Electron Pro Rio – Dropout and Chain Tensioner Notice

2019 and later production frames / Pre-2019 frames

2019 and later

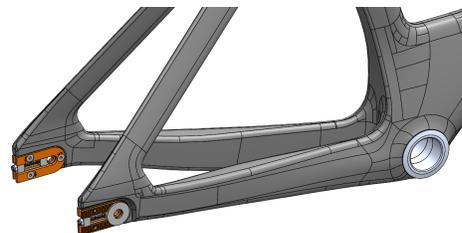
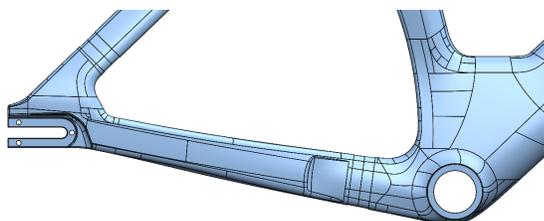
With the introduction of the XS frame in 2019, running changes were made on all sizes of the Electron Pro Rio frames (Sprint and Pursuit).

These changes included the addition of a 65T chainring clearance seatstay notch on all sizes. This modification impacted different parts of the assembly, including longer dropouts and an updated chain tensioner system.

2019 and later frames interior dropout plate features:

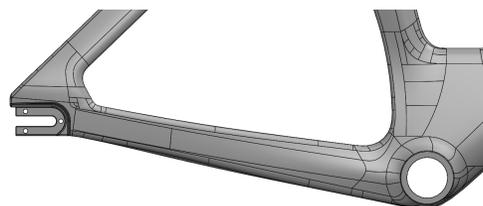
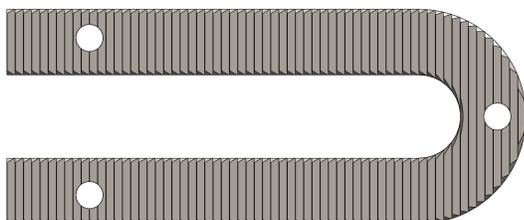
- Longer for more chainstay length adjustability
- Different hole pattern to fit new dropout length
- New chain tension retention surface texture
- Thicker plate (2.5mm instead of 2mm)
- Not compatible with pre-2019 frames

2019 and later frames exterior dropout plate features:

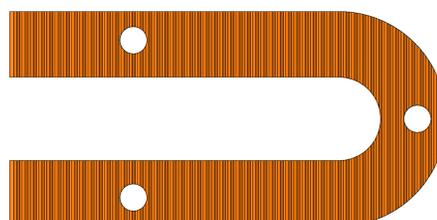
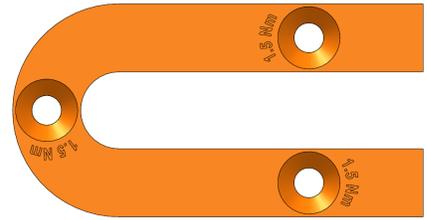
- Longer for more chainstay length adjustability
- Different hole pattern to fit new dropout length
- Identical thickness as pre-2019 plate
- Not compatible with pre-2019 frames

2019 and later frames chain tensioner system

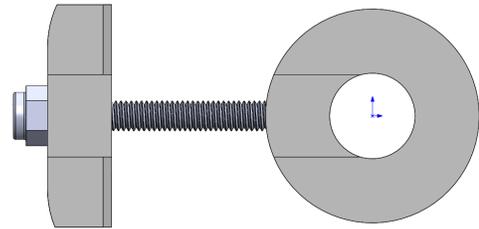
As of 2019, along with the dropouts, the chain tensioner system was also replaced on all Electron Pro Rio frame sizes. This newer system consists of two specially textured washers which engage with the dropout plates. Chain tension is manually adjusted instead of using a screw.

Dropout and chain tensioner system replacement parts:

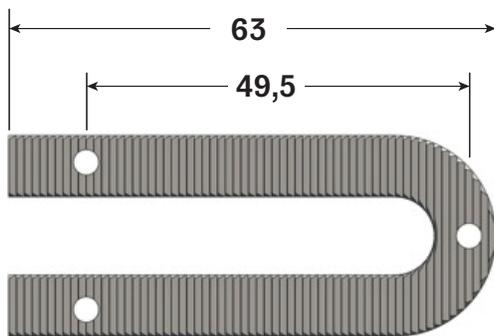
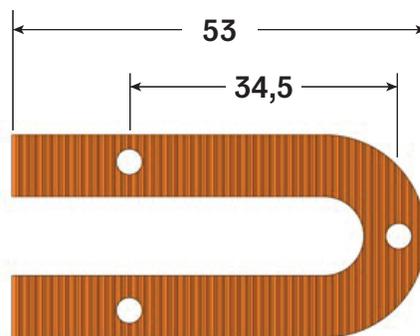
As dropout plates and chain tensioner systems are different and not compatible between Electron Pro Rio frames manufactured in 2019 or later, and pre-2019 models, it is important to order the proper replacement parts for the frame you own.

IMPORTANT: Make sure to measure your current dropout plate to identify which replacement parts should be ordered.

Owners of 2019 or later Electron Pro Rio frames (Sprint or Pursuit) should order the following parts to replace the dropout and chain tensioner system:

2 x **81048** – INTERIOR AND EXTERIOR REAR DROPOUT PLATES, SCREWS AND CHAIN TENSIONER (1 complete kit per side)

Owners of pre-2019 Electron Pro Rio frames (Sprint or Pursuit) should order the following parts to replace the dropout and chain tensioner system:

2 x **80601** – INTERIOR AND EXTERIOR REAR DROPOUT PLATES + SCREWS
(1 kit per side)

1 x **35987** – CHAIN TENSIONER SYSTEM (Kit of 2, good for both sides)
